Description for changes of ML-3051ND

1. Main B'd (V0.2 → V0.4)

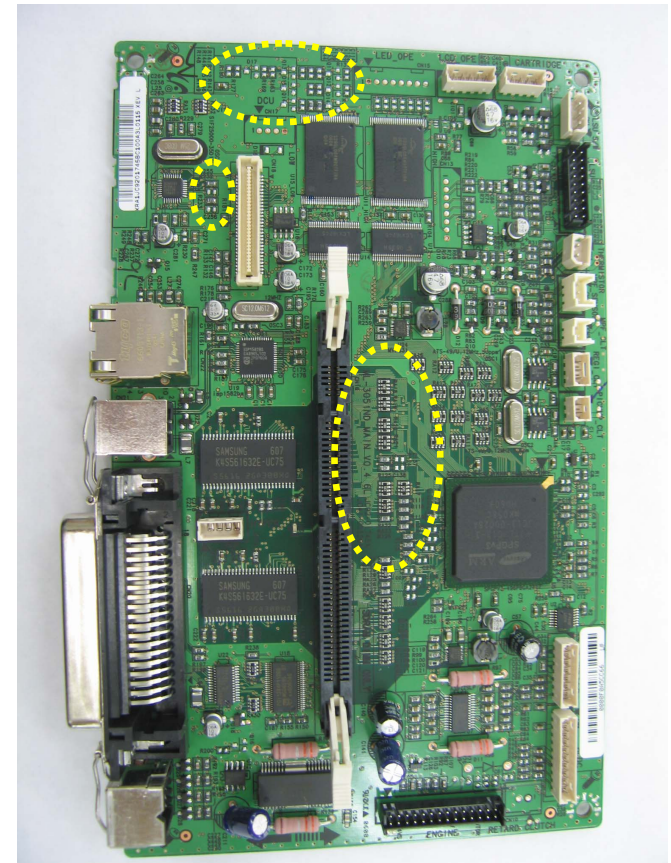
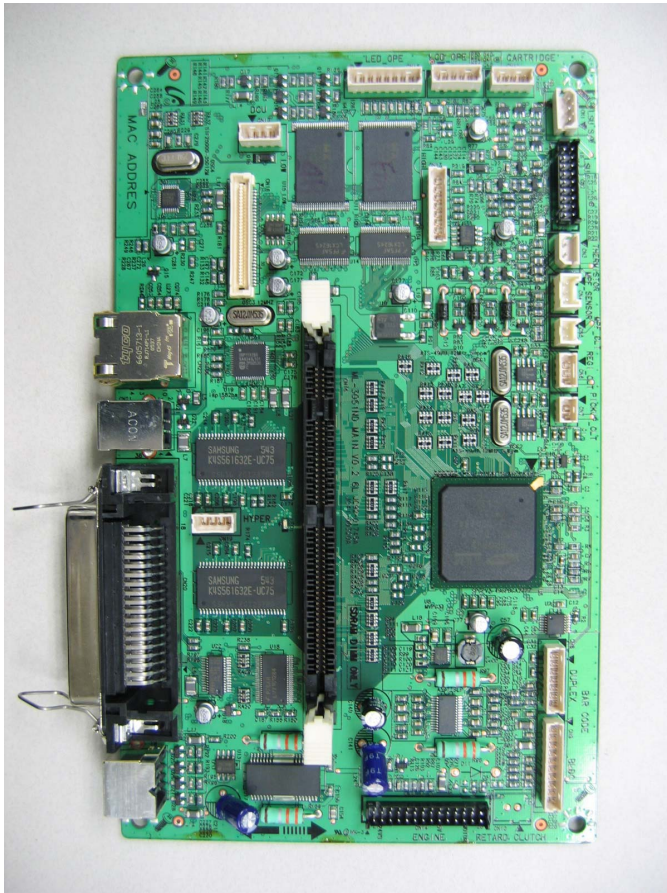
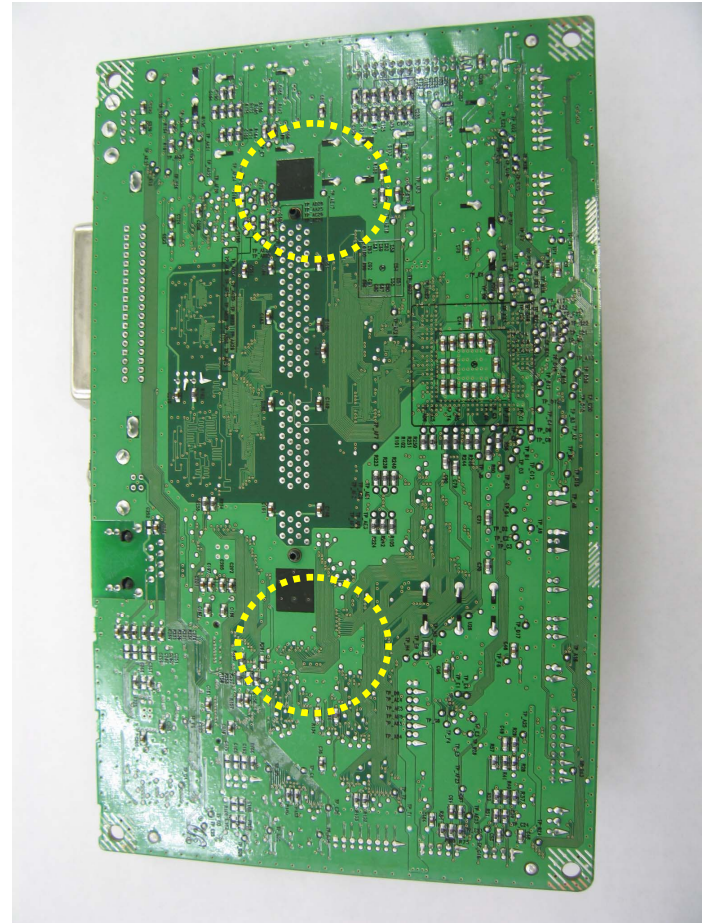
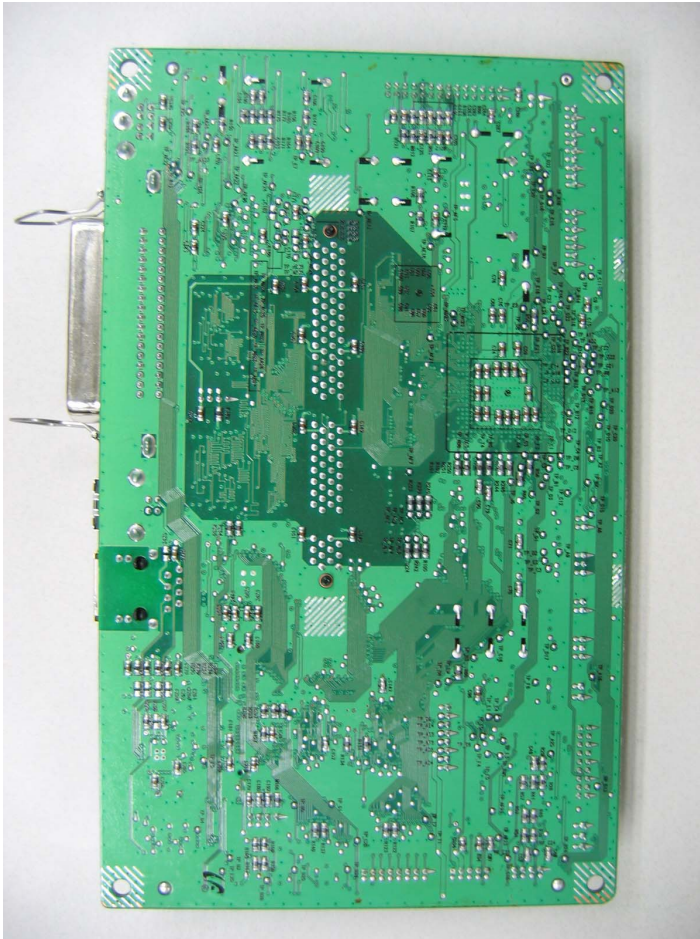
Top View
